REPORT TO COUNCIL

Date: September 28, 2011
File: TA11-0009/OCP11-0006 (LT)
To: City Manager
From: Land Use Management Department, Community Sustainability Division
Subject: Text Amendment to Zoning Bylaw related to Downtown Plan Charrette

Diagram 5.1

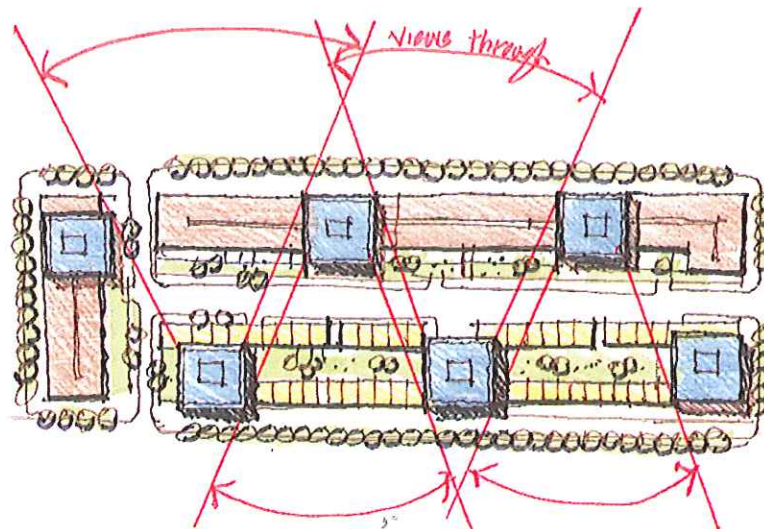
In addition, following Council discussion at the September 19 meeting, it is recommended that the following "Diagram 5.1" be added to the proposed Building Height Policy (5.5.1):

The above diagram illustrates the desired "checkerboard" pattern and sightline angles to be achieved for tall buildings through the revised wording of the Building Height Policy.

AND THAT Bylaw No. 10568 be amended at first reading, to include "Diagram 5.1" as shown in the report of the Land Use Management Department dated September 28, 2011;
